PARTIAL ANCHOR BOLT SETTING PLAN (LEVEL-M3) (SECTOR-A)
(REFER SHEET: S-A-2522)

PARTIAL ANCHOR BOLT SETTING PLAN (LEVEL-M3) (SECTOR-A)
(REFER SHEET: S-A-2512 & S-A-2534)

ANCHOR BOLT SETTING KEY PLAN (SECTOR A-B-C)

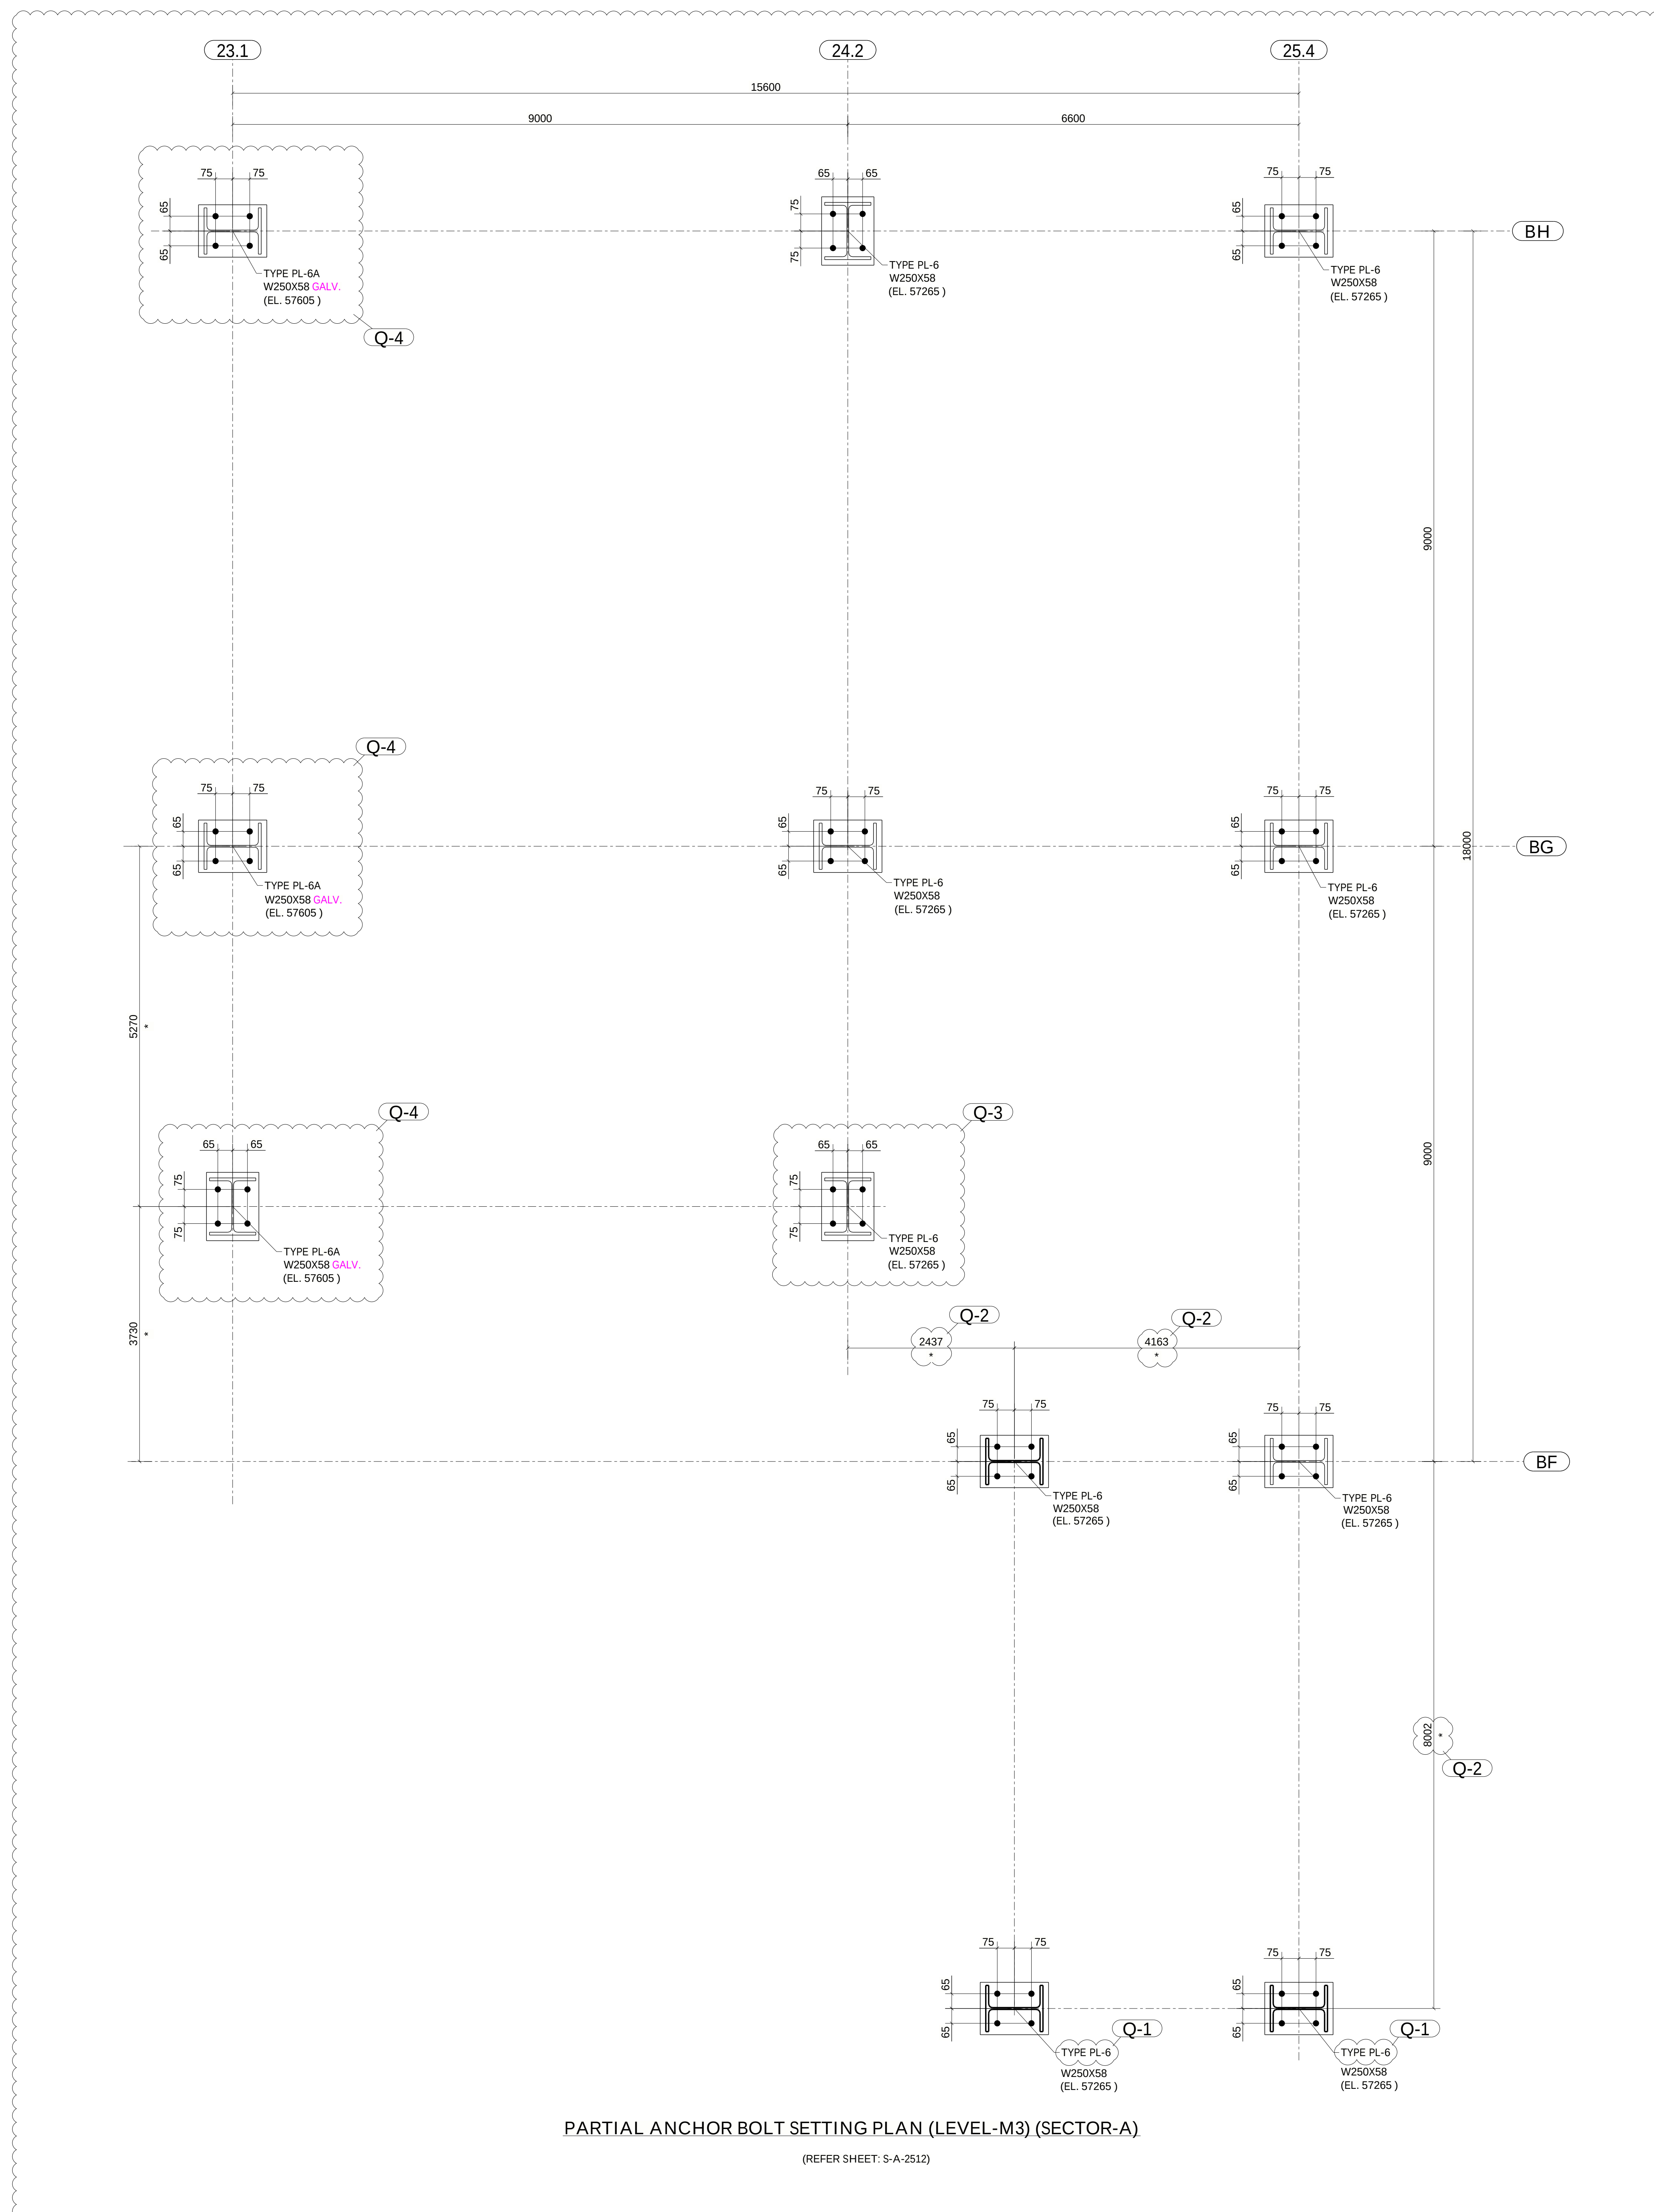
APPROVER VERIFY U/S OF BASE PL. ELEVATION SINCE STRL. PLAN (S-A-2523) DOES NOT SHOWS ANY PIER AT THIS LOCATION. PLEASE VERIFY AND CONFIRM.

APPROVER VERIFY ALL UNDER SIDE OF BASE PLATE ELEVATION, TYPE & ORIENTATION.

APPROVER VERIFY COLUMN LOCATION AND ITS ROTATION.

APPROVER VERIFY/FURNISH ALL CLOUDED INFORMATIONS
